Thurrock Council Response to Lower Thames Crossing - Environmental Impact Assessment Scoping Report

Schedule of Comments and Observations

Promoter	Highways England
Reviewer	Thurrock Council
Document Reviewed	Lower Thames Crossing - Environmental Impact Assessment Scoping Report

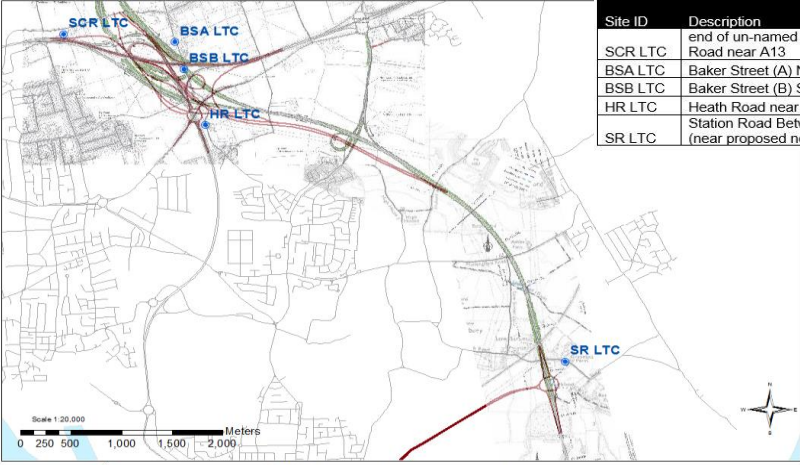
32	Chapter 6 Air Quality / Section 6.4	<p>Thurrock Council have in response to the new proposed road layout set up its own NO2 diffusion tube monitoring sites in key locations as of November 2017. There are a total of five new monitoring locations (see Figure 2). These should be included within Highways England air quality assessment for establishing a baseline and for model verification.</p>
